ATxmega128/64B3

Silicon Errata and Data Sheet Clarification

Figure 3-1. ADC Overview

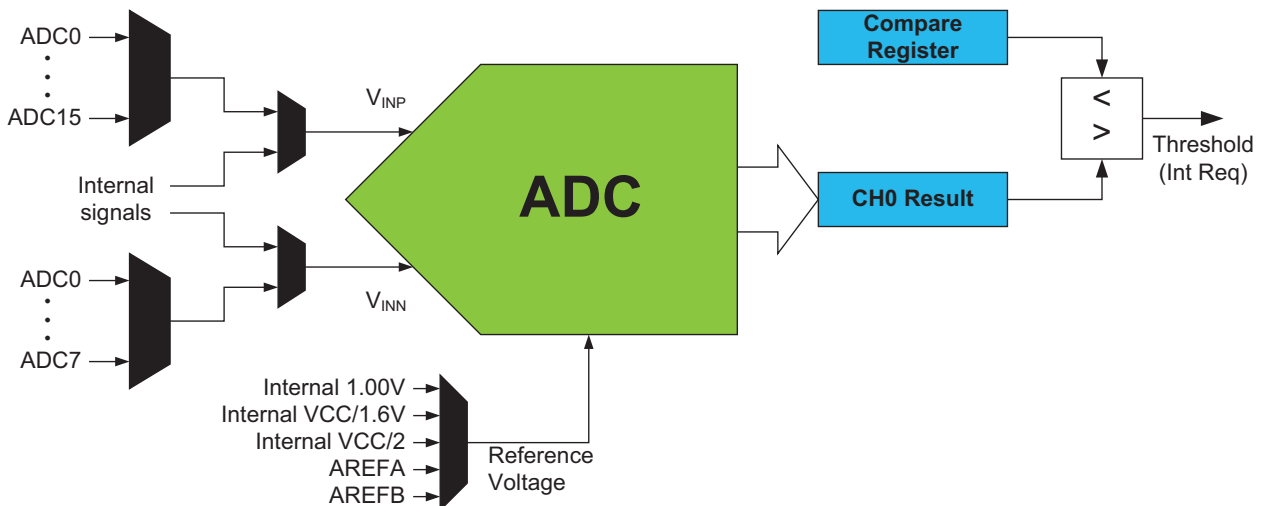
3.2 ADC – 12-bit Analog to Digital Converter

The ADC converts analog signals to digital values. The ADC has a 12-bit resolution and can convert up to 300 thousand samples per second (ksp/s). The input selection is flexible, and both single-ended and differential measurements can be done. An optional gain stage is available to increase the dynamic range for differential measurements.

The ADC can provide both signed and unsigned results. The ADC measurements can be started either by application software or an incoming event from another peripheral in the device. The ADC measurements can be started with predictable timing and without software intervention. When conversions are done, it is possible to use DMA to move ADC results directly to memory or peripherals. Both internal and external reference voltages can be used. An integrated temperature sensor is available for use with the ADC. The ADC can also measure the $AV_{CC}/10$ output and the band gap voltage. The ADC has a Compare function for accurate monitoring of user-defined thresholds with minimum software intervention required.

Note: After the ADC is enabled, the first sample may deviate from the expected result. It is recommended to discard the first sample or accumulate several samples.
